**ERRATA SHEET FOR
ANSI/ASHRAE STANDARD 93-2010
Methods of Testing to Determine the
Thermal Performance of Solar Collectors**

October 9, 2013

The corrections listed in this errata sheet apply to the first printing of ANSI/ASHRAE Standard 93-2010 identified as “Product Code: 86241 4/10” on the outside back cover.

Figure 4 Testing configuration for solar collectors where heat transfer fluid is air.

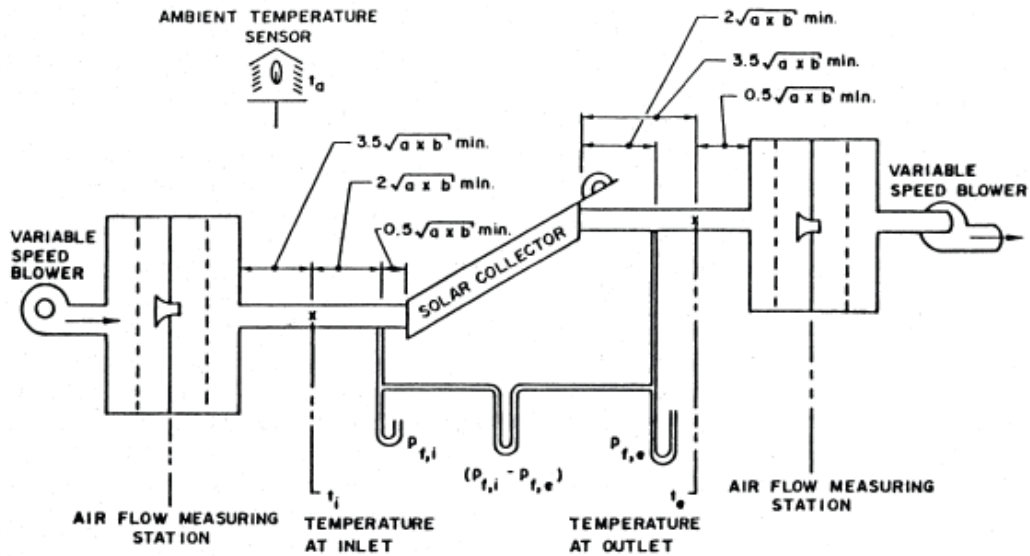
9 Figure 4 Testing configuration for solar collectors where heat transfer fluid is air. Identify the variables a and b in Figure 4 as shown below.

where

a = the height of the air collector air flow opening

b = the width of the air collector air flow opening

(Not to be confused with these letters used as subscripts.)
